**PROPOSED RESIDENTIAL DEVELOPMENT
PARK WEST AVENUE, CHERRY ORCHARD,
DUBLIN 10**

Stage 1 Quality Audit

**(Incorporating a DMURS Street Design Audit, and Audits
of Accessibility, Cycling, Walking and Road Safety)**

Figure 5.1 Drainage

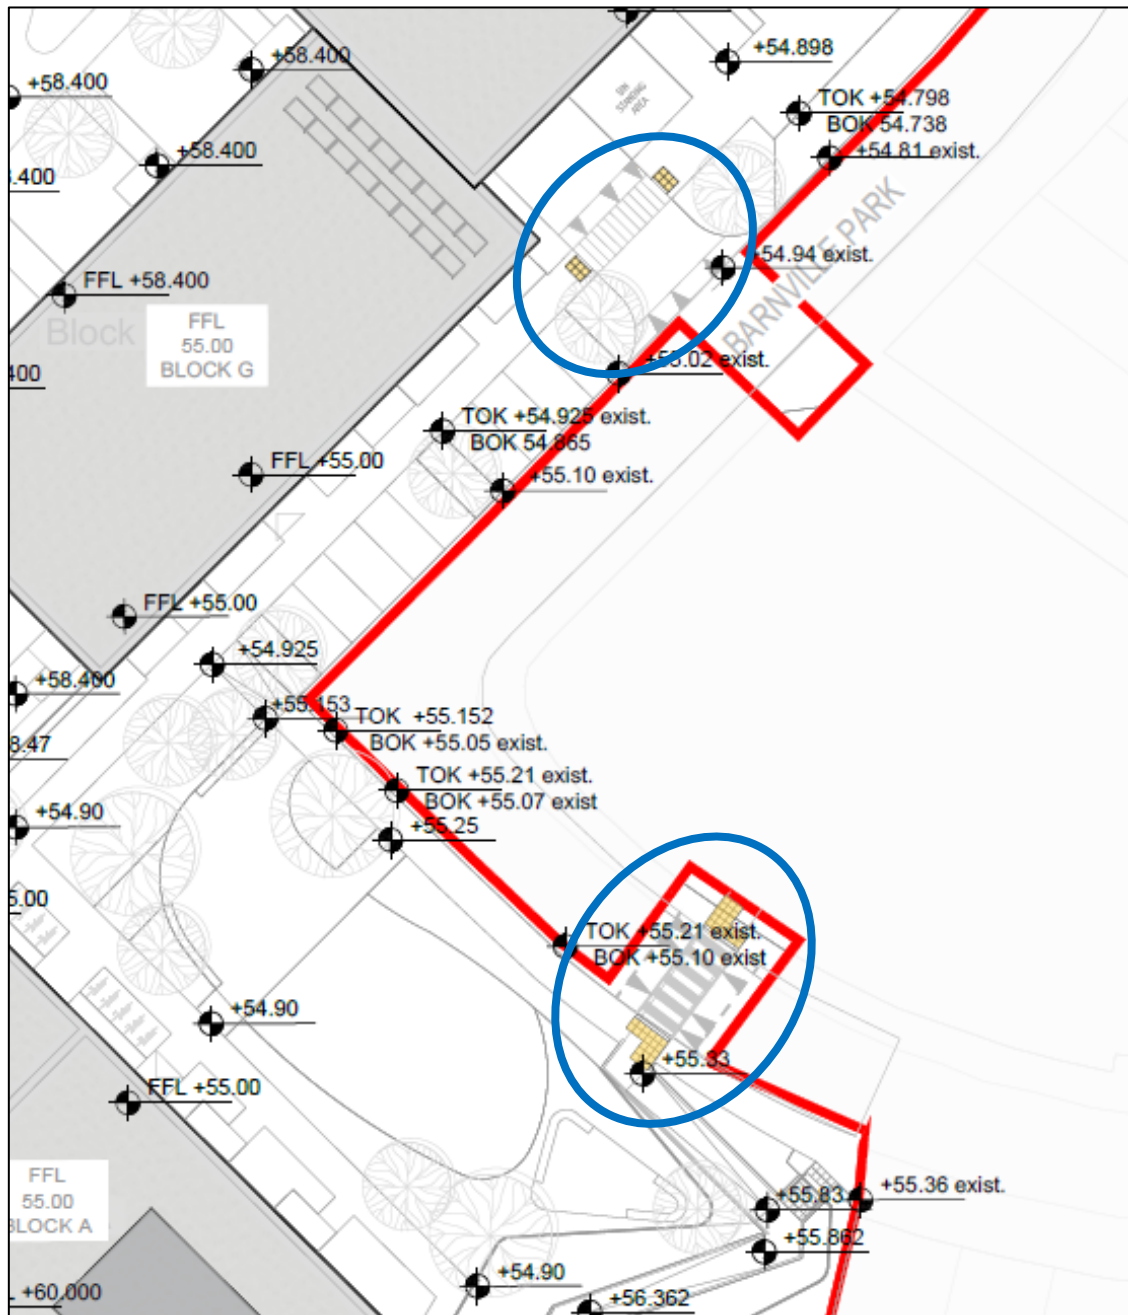
It is unclear what the proposed drainage arrangement will be at proposed raised crossings. Ponding of water and silting can pose a slipping hazard, especially for vulnerable road users.

Ensure adequate drainage measures at all proposed raised crossings throughout the scheme.

5.1	YES	YES	Appropriate drainage facilities such as double gullies on either side of the raised table shall be incorporated into the design to ensure no ponding of surface water at these locations.	-----

Figure 5.2 – Junction Priority

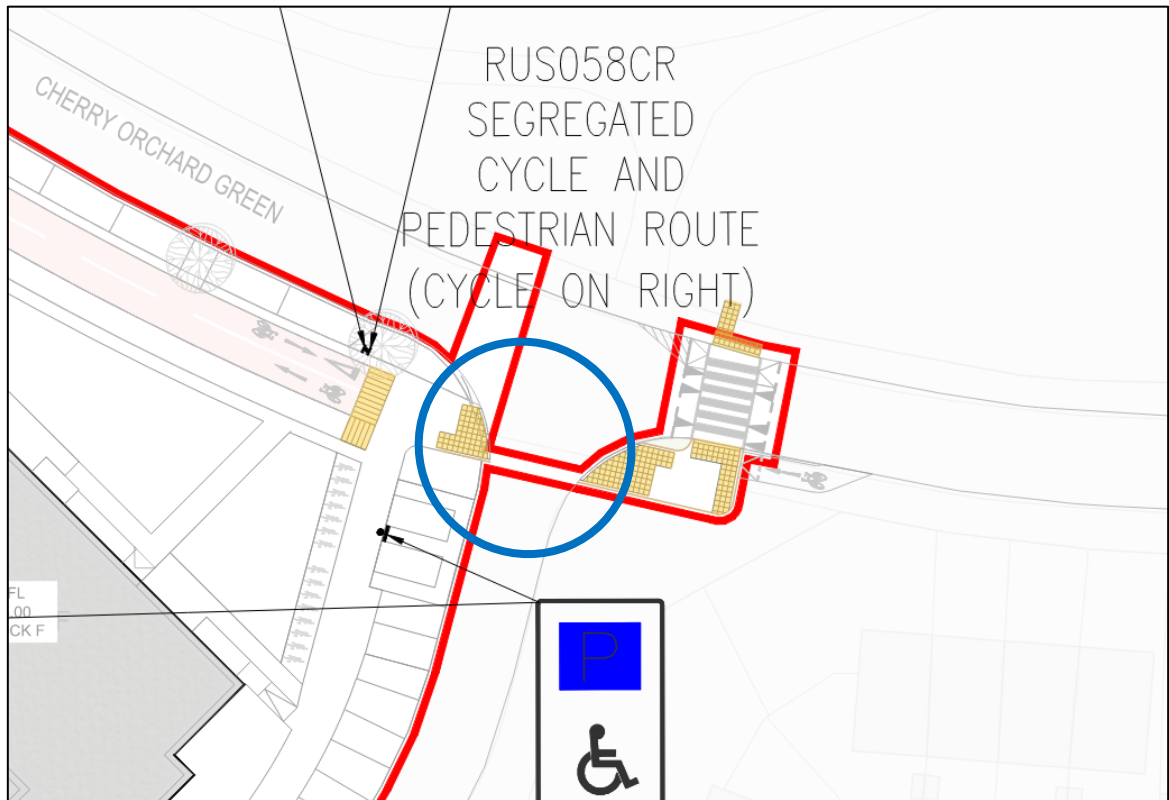
The existing Cherry Orchard Green / Barnville Park junction is not provided with road markings. The absence of appropriate road markings may result in uncertainty regarding junction priority and vehicle positioning, which could lead to driver confusion, inappropriate manoeuvres, and an increased risk of collisions.

Provide appropriate road markings at the existing Cherry Orchard Green / Barnville Park junction.

5.2	YES	YES	There is currently no stop line at this junction. This can be added if required by Dublin City Council.	-----
5.3	YES	YES	The lack of visibility within the visibility splays at the proposed access location to the undercroft parking is acknowledged. The parking spaces along Barnville Park have been shifted to avoid encroachment into the visibility splay. The updated visibility splays are reflected in the current visibility splay drawings.	-----

Figure 5.4 – Visibility Splay Incorrectly Superimposed

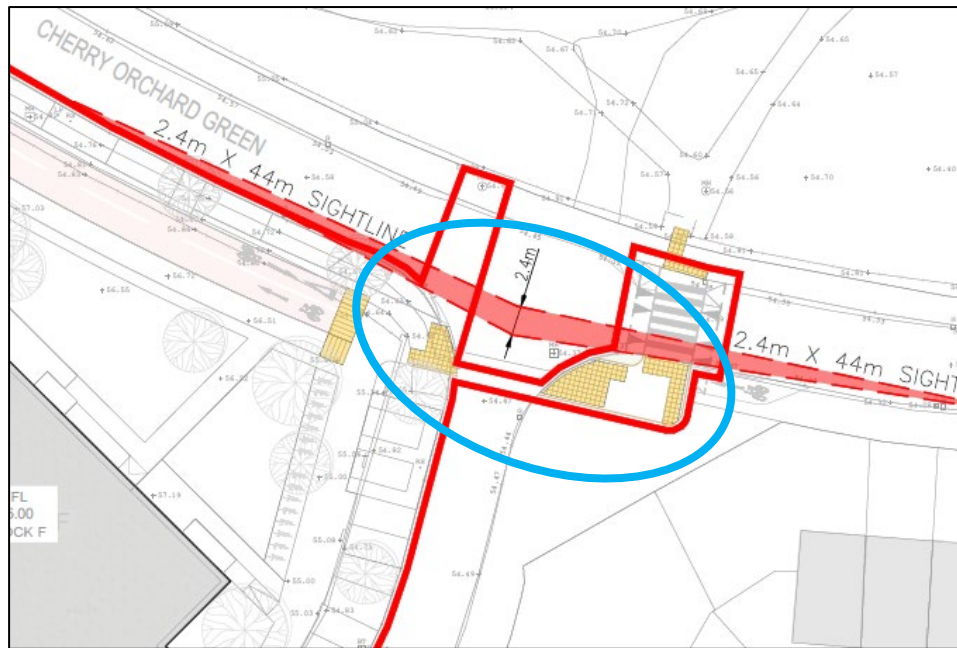
The proposed visibility splay does not appear to be correctly superimposed on the drawings. As a result, it is unclear whether the required visibility standards can be achieved. Inadequate visibility splays may compromise intervisibility between drivers, increasing the risk of vehicular collisions.

Review and amend the drawings to clearly demonstrate the correct location and extent of the required visibility splays. Ensure all visibility splays are adequate, complete and free from obstacles including, but not limited to, parking and planting/trees. Relocate parking and trees as required.

5.4	YES	YES	Updated visibility splays are included in the planning application drawing pack and ensure that parking spaces and trees are clear of the visibility splays at this junction location.	-----

Figure 6.2 – Visibility Compromised at Pedestrian Crossing

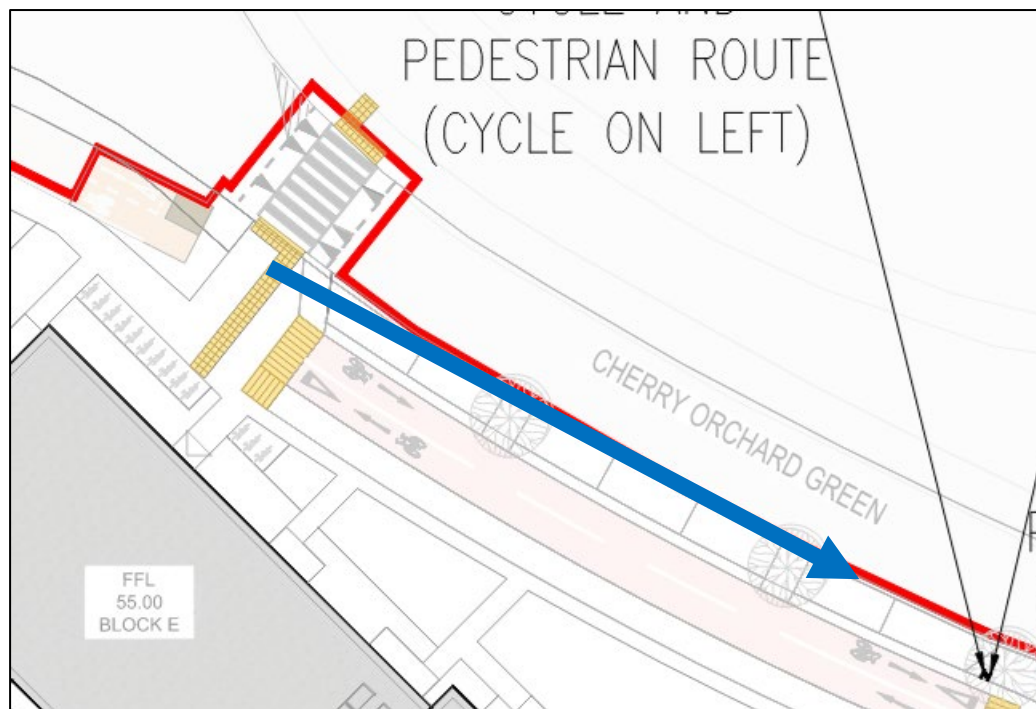
Intervisibility between pedestrians crossing pedestrian crossings and drivers of vehicles approaching the crossings may be restricted by vehicles parked in the adjacent car parking spaces or landscaping adjacent to the pedestrian crossings. A lack of adequate intervisibility may contribute to a collision at these locations.

Ensure adequate intervisibility between pedestrians and motorists. Relocate parking and landscaping as required.

5.5	YES	YES	The lack of intervisibility between vehicles and pedestrians at this location is noted. The proposed parking spaces along Cherry Orchard Green have been shifted to facilitate clear visibility between vehicles and pedestrians using the road crossing.	-----

Figure 5.5 – Swept Path Analysis

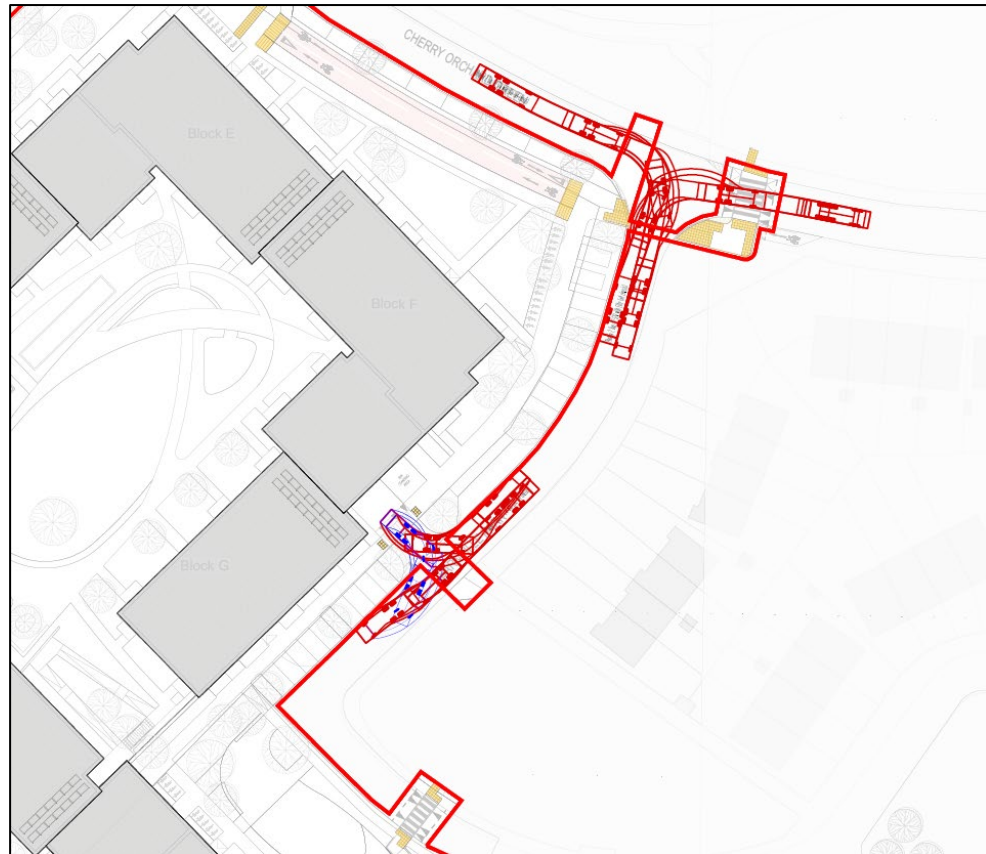
Swept Path Analysis drawings have been provided for certain vehicle movements; however, they do not demonstrate vehicle manoeuvrability throughout the proposed internal car park. As a result, it is unclear whether sufficient space is available for all vehicles to manoeuvre safely within the development. Inadequate manoeuvring space may result in encroaching into opposing traffic lanes or pedestrian areas, or undertaking multi-point turns, increasing the risk of vehicular collisions and injuries to vulnerable road users

Ensure adequate manoeuvrability space on all road networks for all vehicle types.

5.6	YES	YES	Swept path analysis for a large vehicle within the undercroft parking area has been included in the planning application drawing pack	-----

and clearly demonstrates the manoeuvrability of vehicles within the undercroft. Refuse and fire tender vehicles are not proposed to access or utilise the undercroft parking area.

Figure 5.6 – Raised Ramps in close proximity to the Raised Pedestrian Crossing

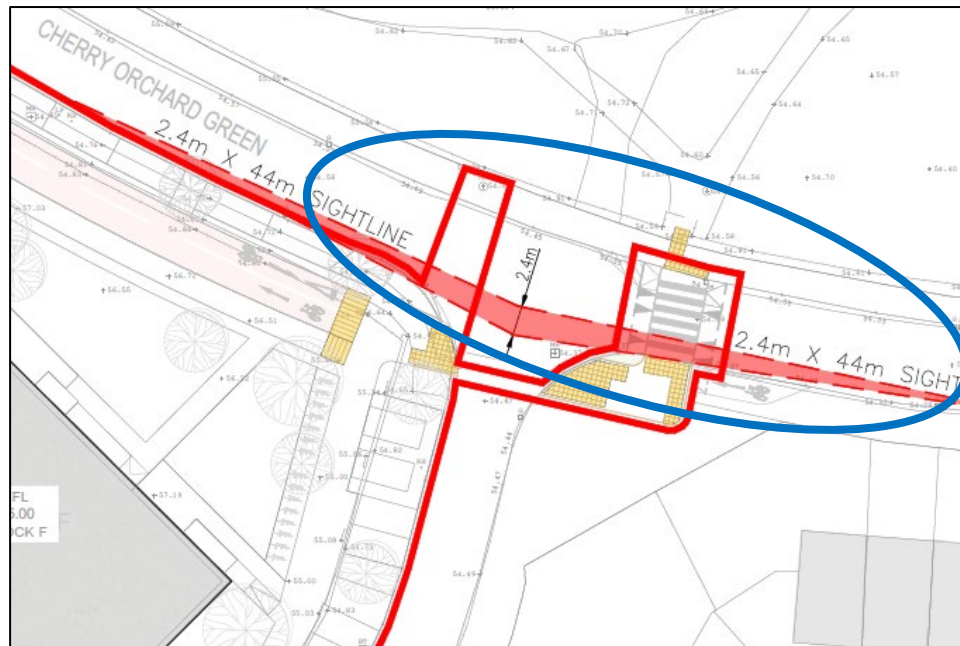
A raised pedestrian crossing is proposed on the eastern side of the Cherry Orchard Green / Barnville Park junction. It was noted during the site visit that existing speed ramps are currently located on both the western and eastern approaches to the junction, approximately 15 m to 20 m from the proposed raised crossing. The close proximity of multiple vertical traffic calming features may result in inconsistent driver behaviour, discomfort for vehicle occupants, and increased braking and acceleration manoeuvres. This could lead to driver distraction and an increased risk of vehicle conflicts in the vicinity of the junction and crossing.

Review the spacing and interaction between the proposed raised pedestrian crossing and the existing speed ramps to ensure an appropriate and consistent traffic calming strategy is provided. Consider the removal, relocation, or modification of existing traffic calming measures where necessary to reduce the potential for driver confusion and to maintain a safe environment for all road users.

5.7	YES	YES	Both existing speed ramps will be replaced by the proposed speed ramps at the northeast of the development, at the junction of Cherry Orchard Green and Barnville Park, and at the northwest of the development on Cherry Orchard Green.	-----

Figure 5.7 – Junction Priority

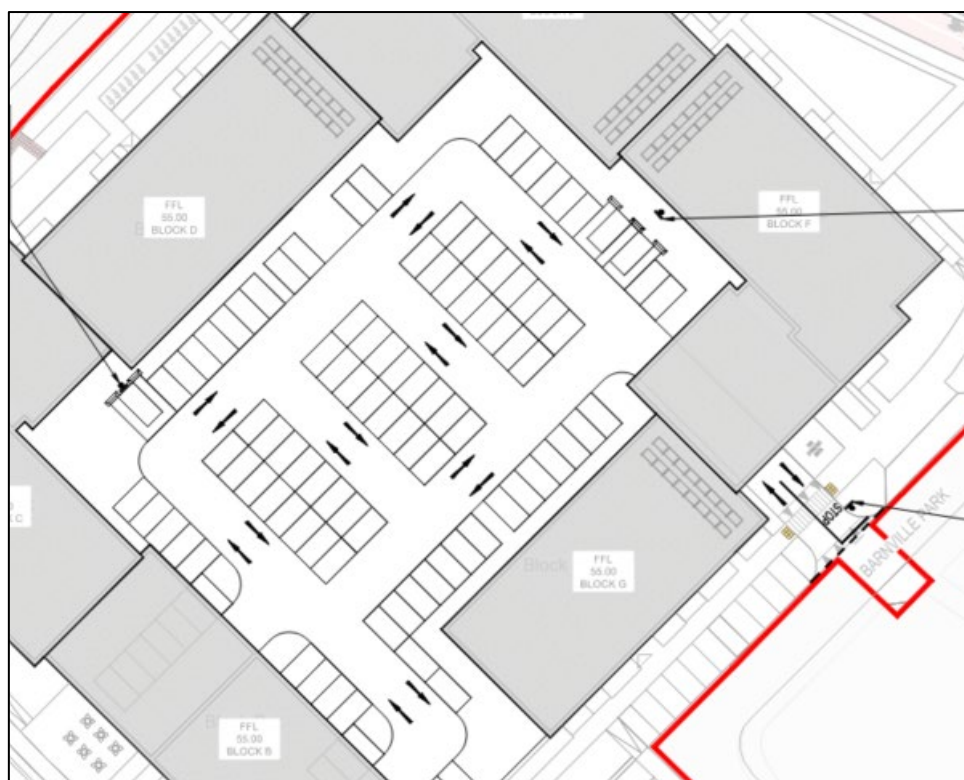
Priority arrangements at the internal junctions within the proposed car parking area are not indicated on the drawings. The absence of clearly defined priority may result in uncertainty among drivers regarding right-of-way, leading to hesitation, inappropriate manoeuvres, or conflicting vehicle movements. This could increase the risk of vehicular collisions and may also present a hazard to pedestrians moving through the car parking area.

Provide appropriate road markings at the internal junctions within the car park area.

5.8	YES	YES	Appropriate road markings and priority junctions have been included in the updated design and are reflected in the roads markings and signage drawings submitted under the planning application.	-----

Figure 6.1 – Shared Footpath

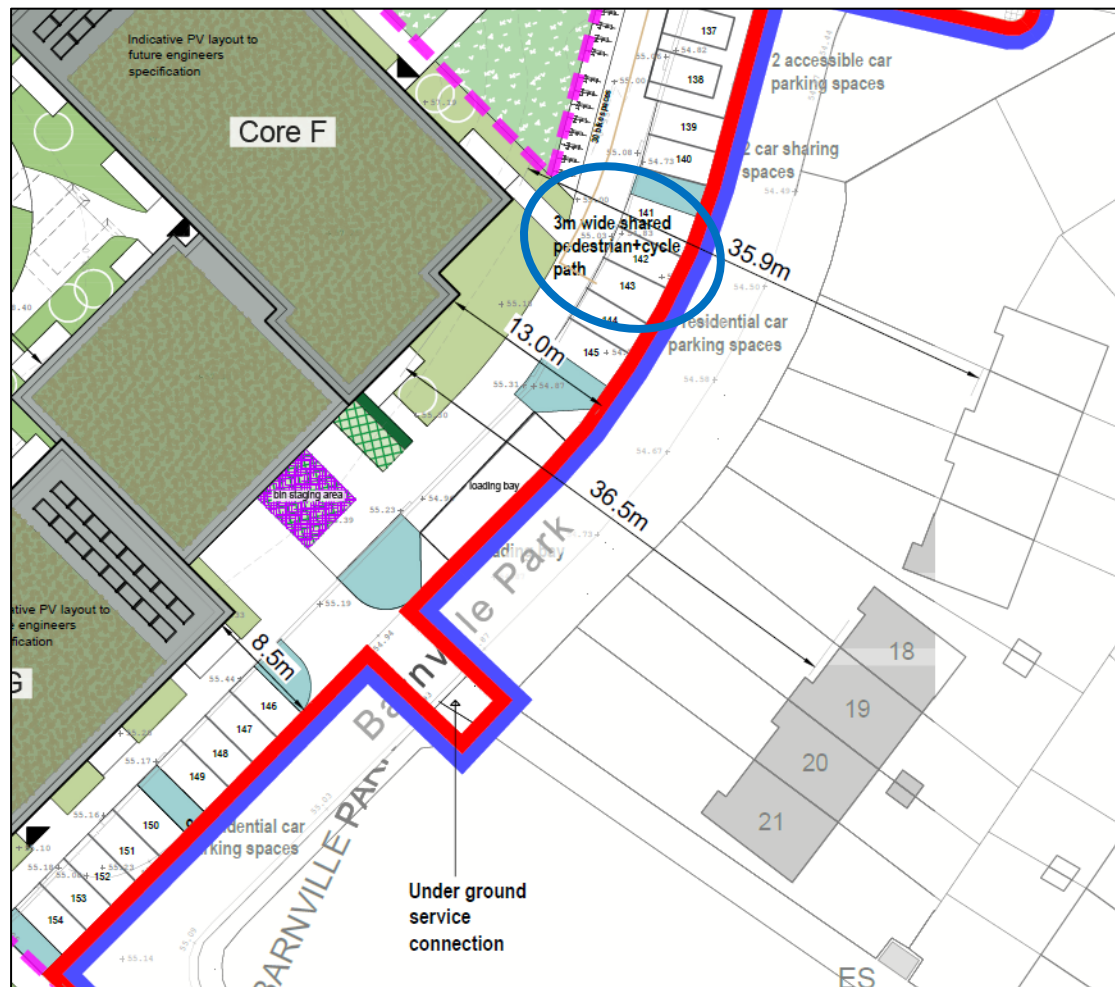
A proposed shared footway (pedestrians and cyclists) will result the user comfort for both modes, especially in a development with reduced parking levels.

Consider segregated footway and cycleway. Ensure adequate cross-sectional width, and thereby level of service, for both modes of transport based on anticipated volumes of users.

6.1	YES	PARTIALLY	The recommendation to consider segregated cycle and pedestrian facilities is noted. A segregated cycle track and footpath are provided along the northern and eastern fronts of the development, in line with the primary roads and main cyclist routes.

Figure 6.2 – Likely Pedestrian Desire Lines without Crossing

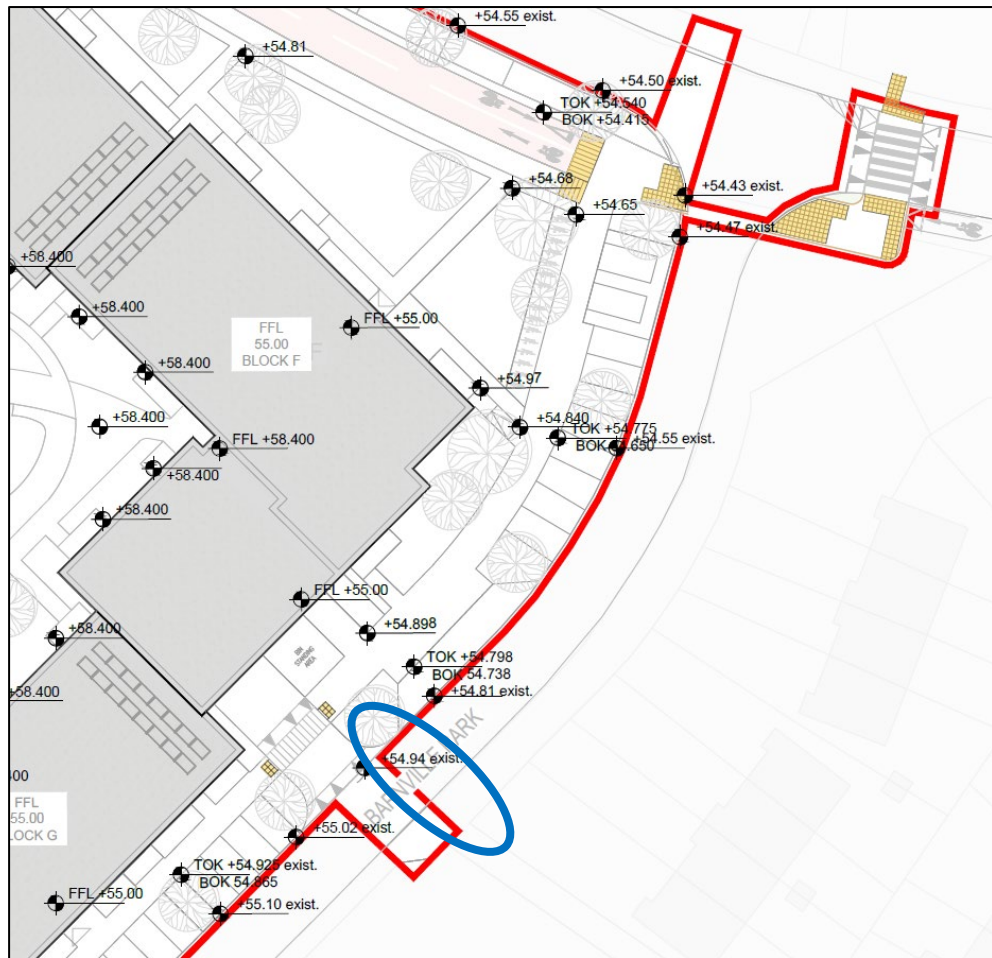
Infrastructure along pedestrian desire lines is not exhaustive along likely desire lines. This may reduce the attractiveness of walking as a mode of transport.

Ensure adequate pedestrian infrastructure along all likely crossing points and desire lines.

Figure 6.3 – Pedestrian Routes adjacent to Sheffield stands

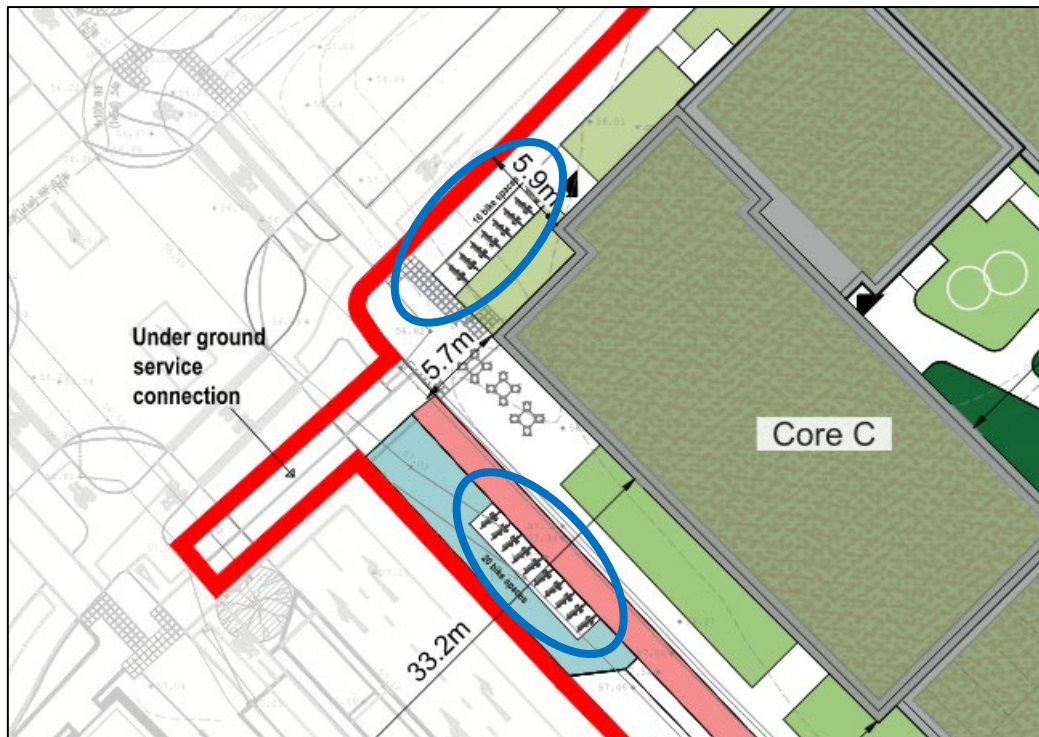
Sheffield Stands are proposed immediately adjacent to footpaths/shared space/cycletracks in a number of locations including but not limited to the locations shown in the image below. Poorly stored cycles may overhang onto the footpath/shared space area reducing its capacity.

Ensure adequate separation between the cycle parking areas and the adjacent footpaths/shared space/cycletracks.

6.2	YES	YES	
6.3	YES	PARTIALLY	The interface between the proposed cycle parking facilities and adjacent footpaths, shared spaces and cycle tracks is noted. The location and arrangement of the cycle parking facilities will be reassessed where appropriate to ensure suitable integration with the surrounding pedestrian and cyclist facilities.
